IREDELL COUNTY HEALTH DEPARTMENT

IMPROVEMENT PERMIT / AUTHORIZATION TO CONSTRUCT / OPERATION PERMIT / EXISTING SYSTEM INSPECTION

PERMIT# 10102820 PIN# 4717 74 4450

SUBDIVISION Mtn View Est BLOCK / SECTION — LOT 40 LOT AREA 1.03 Ac SITE CLASS. PS DESIGN FLOW 360 L.T.A.R. .30 g/d/ft

INITIAL SITE SKETCH Scale 1" = 150'

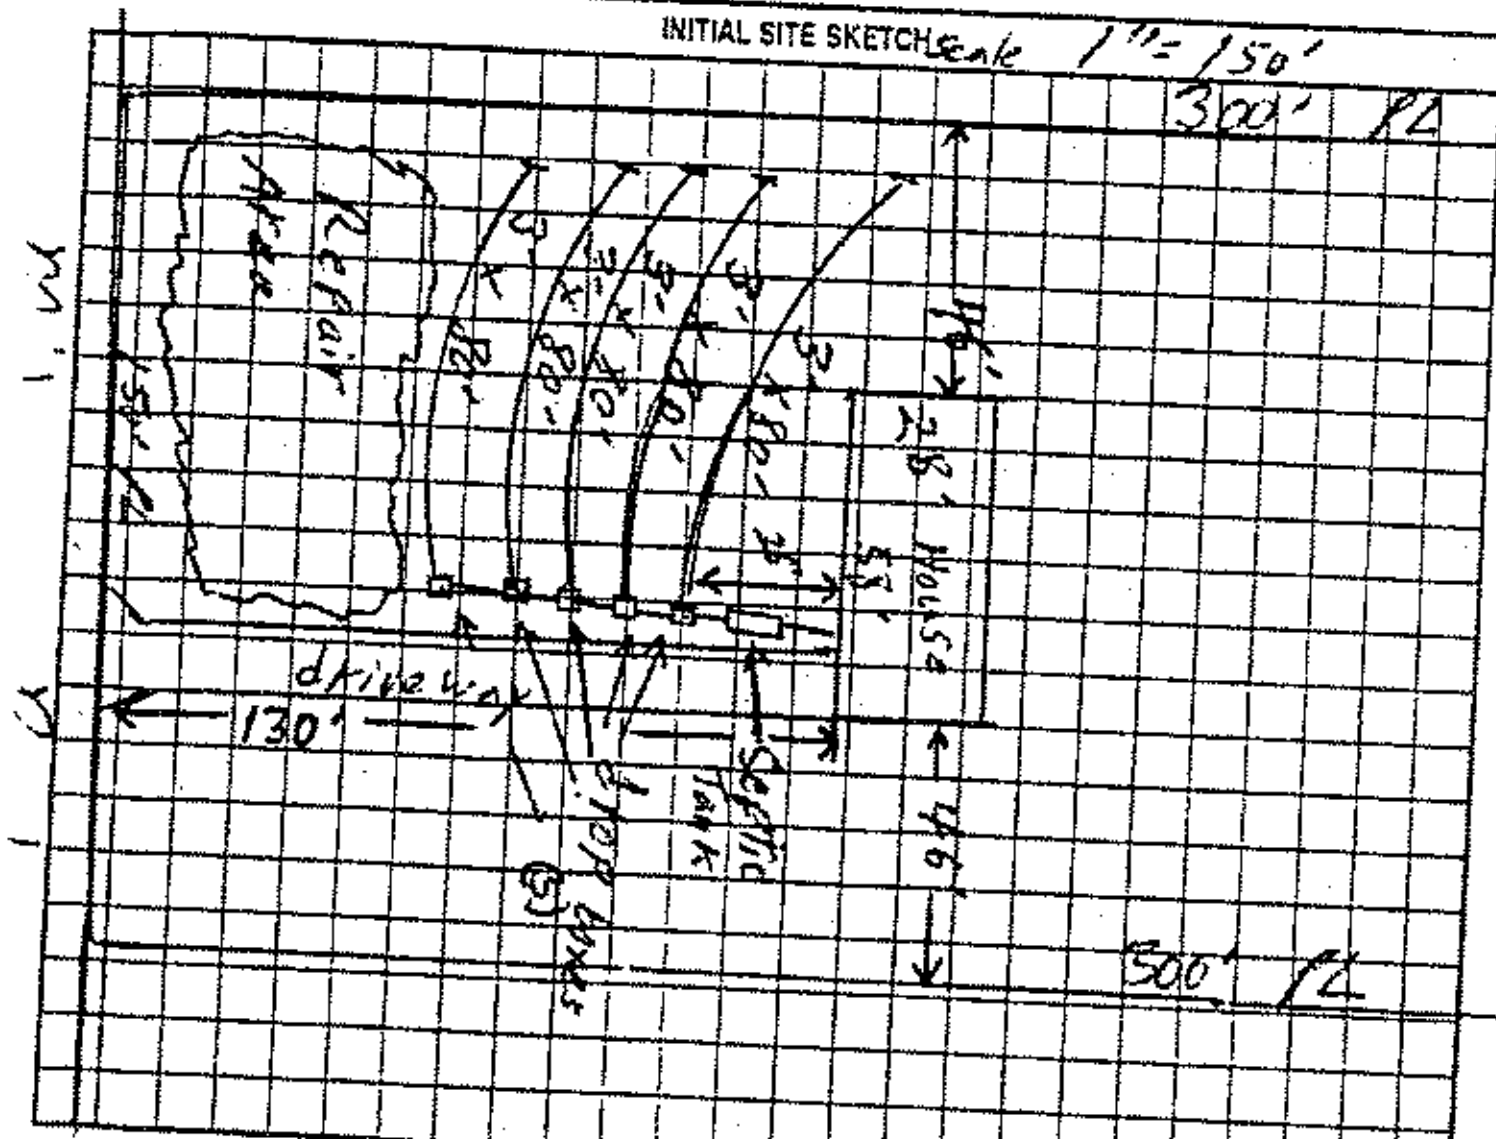
Comments/Conditions: (1) Do not install when wet (2) Install on contour (3) Keep 10 ft from property lines

AS BUILT SKETCH

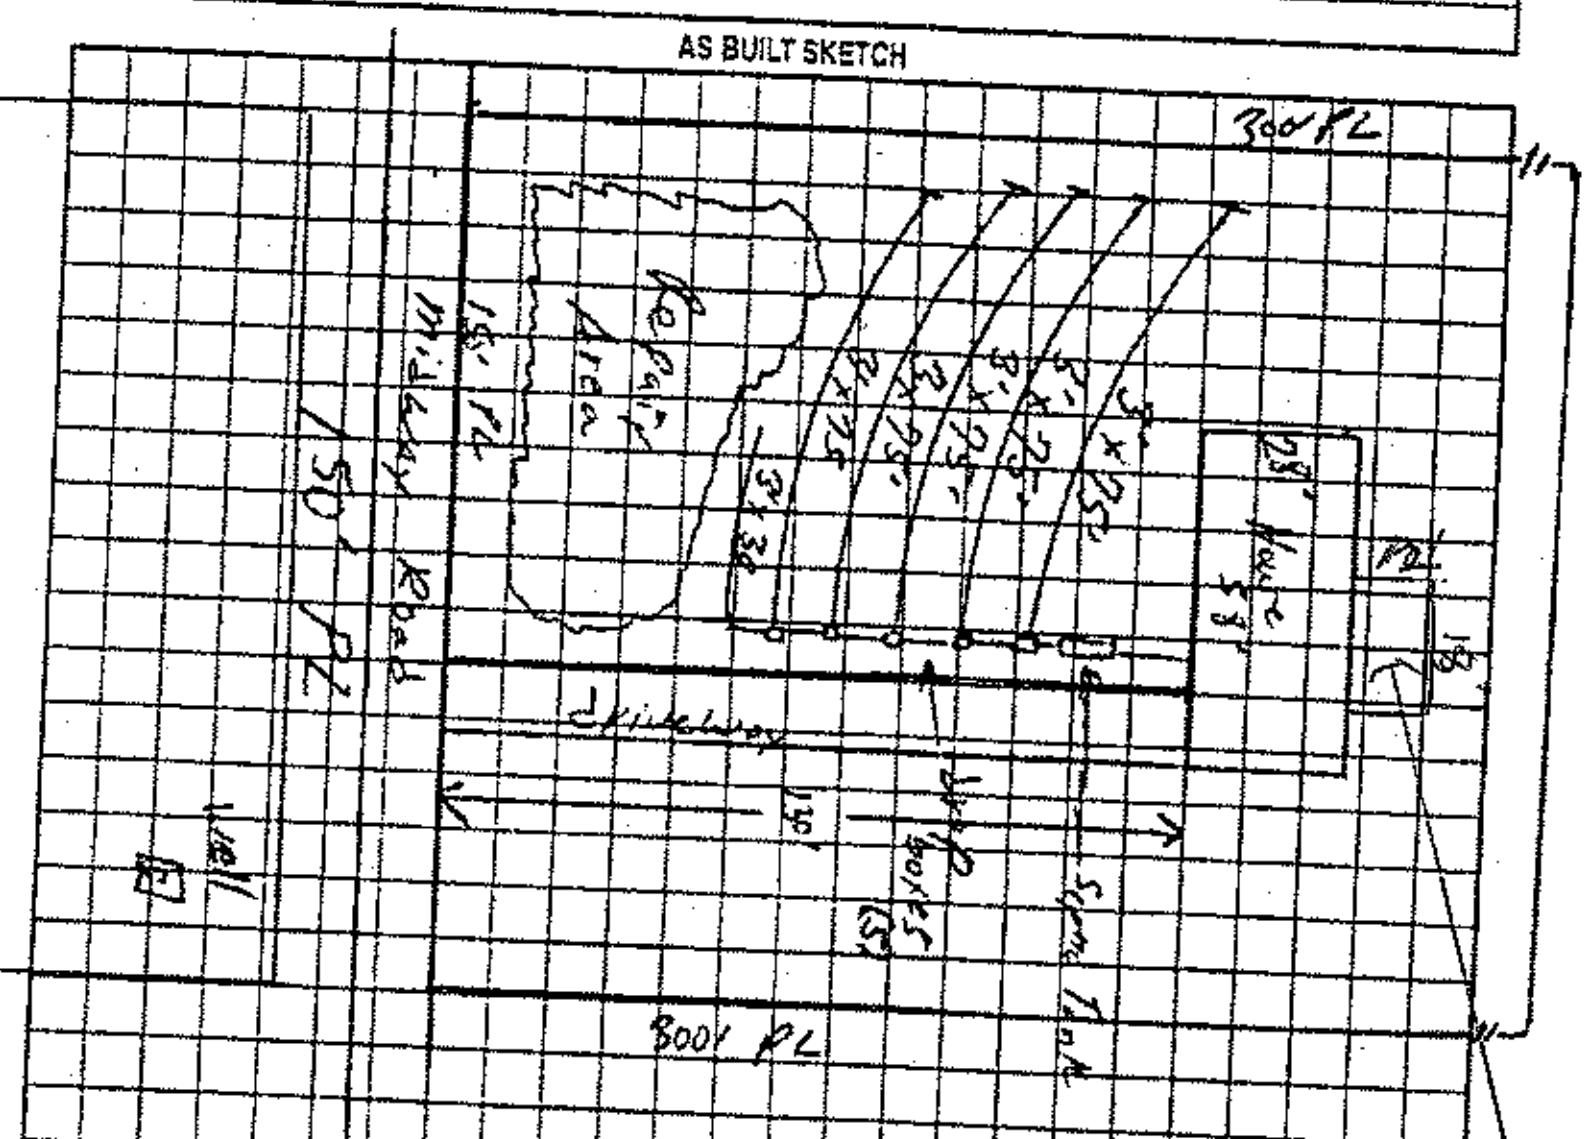
Comments/Conditions: 6 Lines Installed with dropboxes

Location of the proposed Laundry + Sunroom **addition does not appear to impact the existing on-site septic system or well.**NOTE:** ______
